Browns Ferry Nuclear Plant, Unit 1
Renewed Facility Operating License No. DPR-33
NRC Docket No. 50-259

Subject: **License Amendment Request under Exigent Circumstances for the Administrative Change to Remove the Notes on Technical Specification Figures 3.4.9-1 and 3.4.9-2**

**TENNESSEE VALLEY AUTHORITY
BROWNS FERRY NUCLEAR PLANT UNIT 1**

EVALUATION OF PROPOSED CHANGE

**Figure 3.4.9-1
Pressure/Temperature Limits for
Mechanical Heatup, Cooldown following Shutdown, and
Reactor Critical Operations**

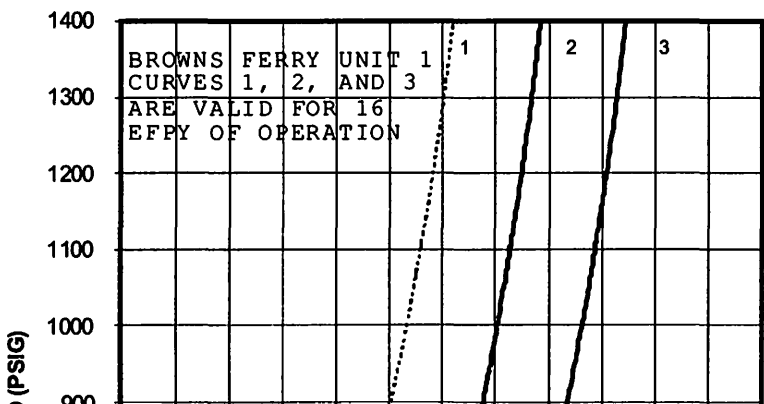
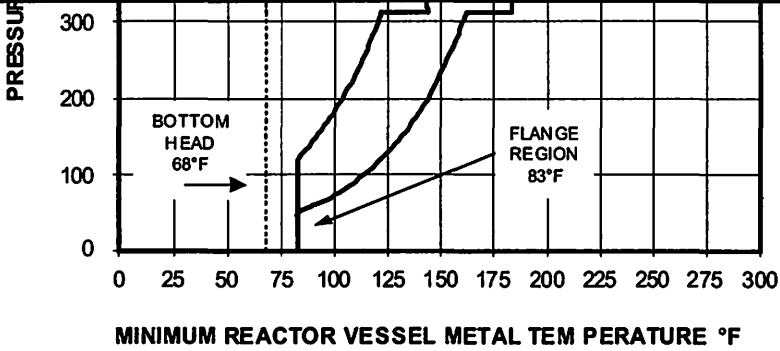
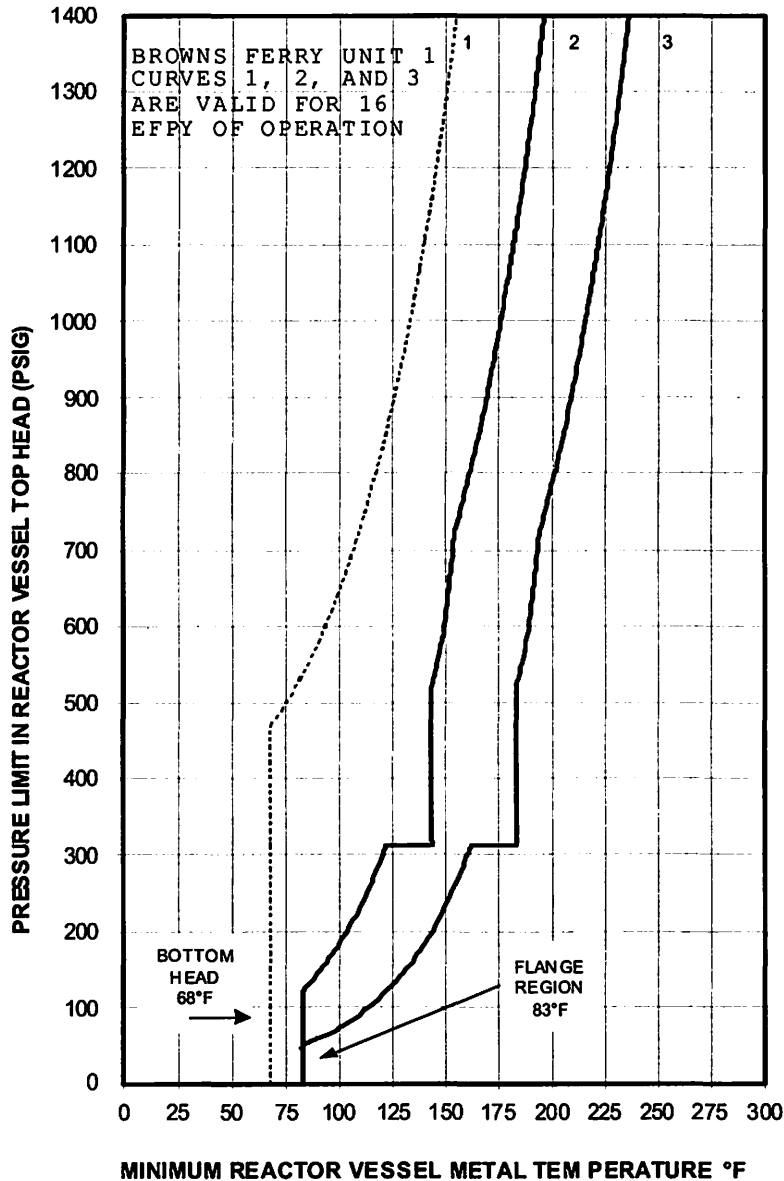
delete Note
from this
page

DO NOT USE THIS FIGURE

This curve applies to operations >12 EFPY.

For current operation, use previous curve, which is valid up to 12 EFPY.

The proposed administrative change deletes the Note covering the P/T curves on the two TS figures. Furthermore, by deleting the two Notes, the two curves would be shown in their entirety, in lieu of being partially obscured.

In addition, the top right page header on both TS figures contains the title "Reactor Steam Dome Pressure." The proposed change modifies this page header to correctly identify the associated TS as "RCS P/T Limits."

Figure 3.4.9-2
Pressure/Temperature Limits for
Reactor In-Service Leak and Hydrostatic Testing

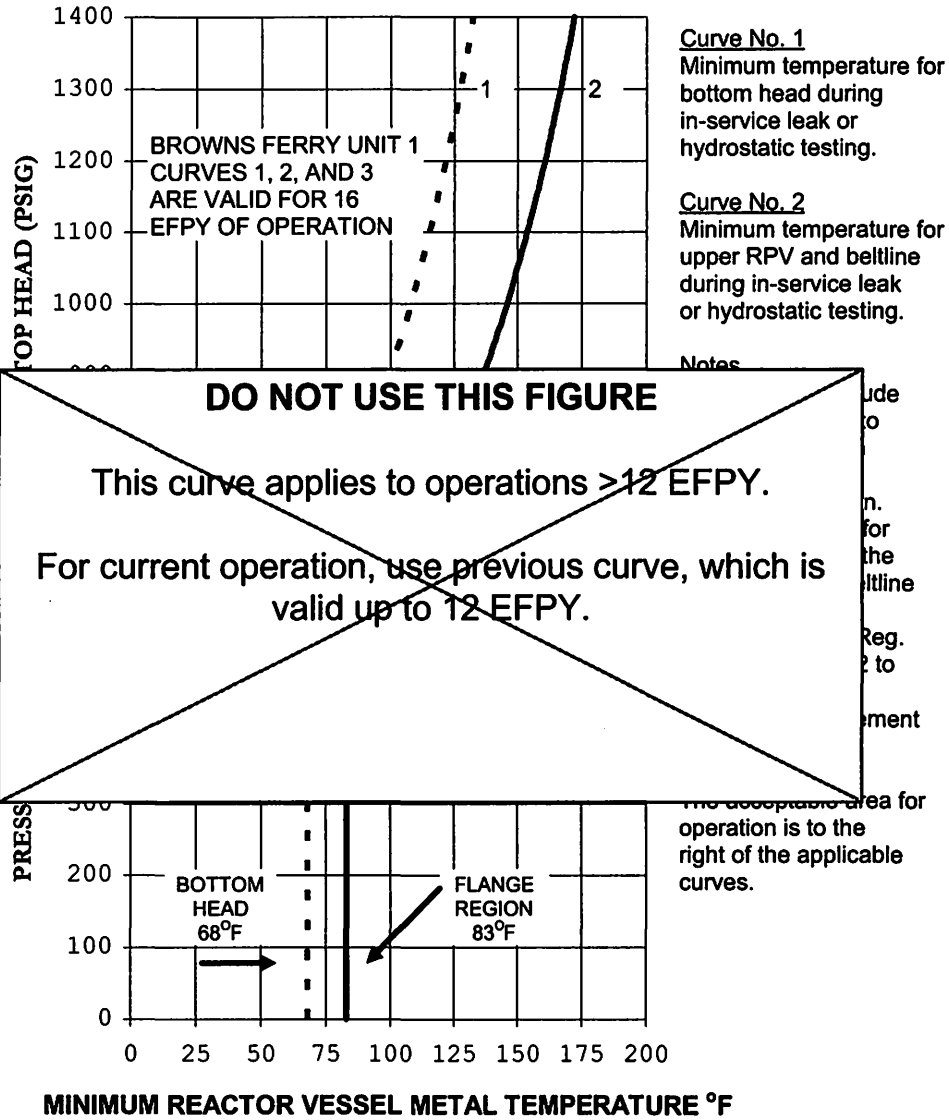
delete Note
from this
page
